RC1: 'Comment on egusphere-2025-938', Niklas Kühne

RC2: 'Comment on egusphere-2025-938', Anonymous Referee #2, 20 May 2025

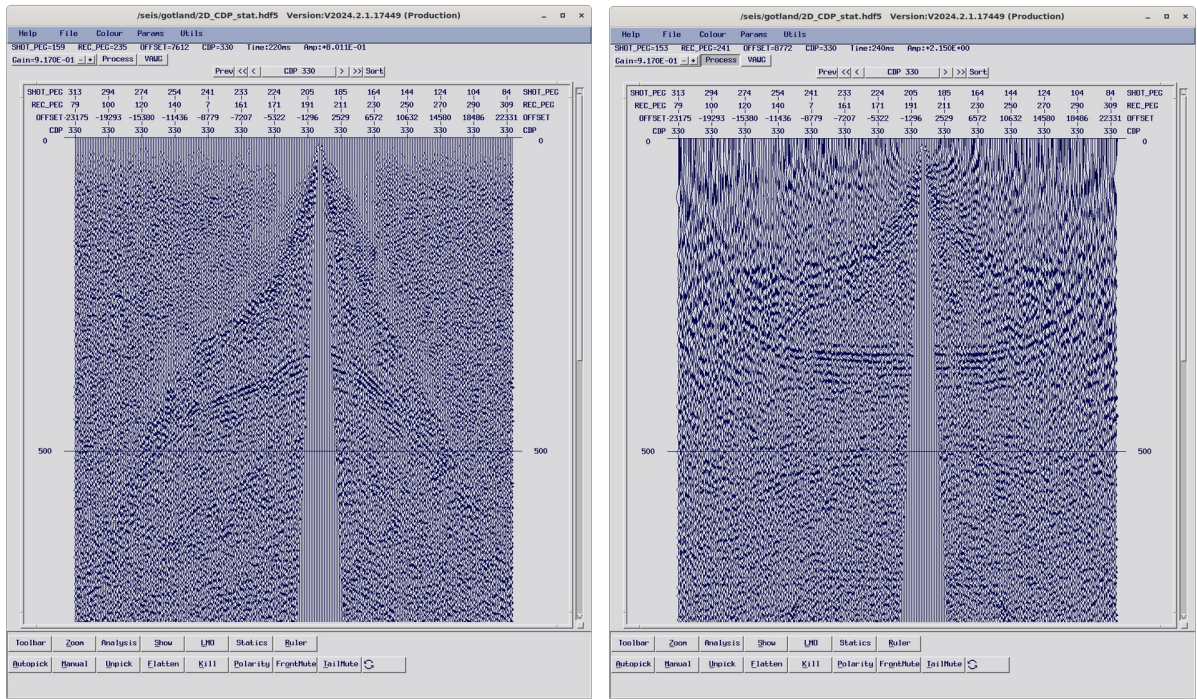
Technically, while the study identifies significant anisotropy (~13%) and uses DAS and sonic logs to refine depth conversion, the seismic processing workflow appears overly simplistic for the complexity of the subsurface. In particular, the absence of anisotropic migration or advanced velocity modelling limits the accuracy of structural interpretation and reflector positioning. Clarifying these limitations and discussing their implications would add value, especially given the study’s aim to extrapolate to the offshore CO₂ storage.

Response: We do not understand this comment. The subsurface is essentially 1D with very little structure. The reflection moveout is hyperbolic and the reflections are horizontal after NMO (see CDP gather below with constant NMO of 3500 m/s applied). Advanced processing will do little to improve the image and may introduce artifacts. We have added the sentence “Given the 1D structure of the area and the variable fold we have chosen not to present migrated results since migration introduces some artifacts into the volume.”
